Intersection ID: 27927	Main Street: FAIR_ISLE_DR	Cross Street: INNES_CT	Location:	SW
ADA ID: 9C8F8D87858F	Ramp Type: PerpDiag	Initial Pass/Fail: Fail	Overall Compliance: No	Severity Score: 12.5

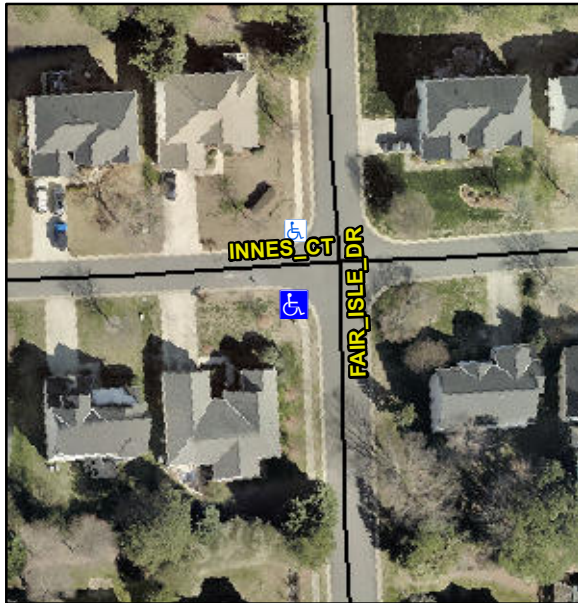
Compliance	Description	Data	Compliance	Description	Data
N/A	Ramp Length (in)	41.0	Yes	Ramp Slope (%)	5.5
Yes	Ramp Width (in)	141.0	No	Ramp XSlope (%)	5.4
N/A	Flare Type LT	N/A	N/A	Flare Type RT	N/A
N/A	Flare Slope LT (%)	N/A	N/A	Flare Slope RT (%)	N/A
N/A	Flare Traversable LT?	N/A	N/A	Flare Traversable RT?	N/A
N/A	Landing Length (in)	N/A	N/A	DWS Provided?	N/A
N/A	Landing Width (in)	N/A	N/A	DWS Contrast?	N/A
N/A	Landing Slope (%)	N/A	N/A	DWS Length (in)	N/A
N/A	Landing X Slope (%)	N/A	N/A	DWS Full Width?	N/A
N/A	Landing Curb? (Y/N)	N/A	N/A	DWS Offset (in)	N/A
N/A	Shared Landing?	N/A			
N/A	Gutter Ponding?	N/A	N/A	Gutter Slope (%)	N/A
N/A	Gutter Lip Ht (in)	N/A	N/A	Gutter X Slope (%)	N/A
N/A	Painted X Walk1?	No	N/A	Painted X Walk2?	No
	X Walk 1 Direction	To E		X Walk 2 Direction	To N
N/A	X Walk 1 Width (in)	N/A	N/A	X Walk 2 Width (in)	N/A
	X Walk 1 Slope (%)	2.3		X Walk 2 Slope (%)	0.5
	X Walk 1 X Slope (%)	2.0		X Walk 2 X Slope (%)	2.1

Remove & Replace Curb Ramp With Two New Directional Ramps or Equivalent.
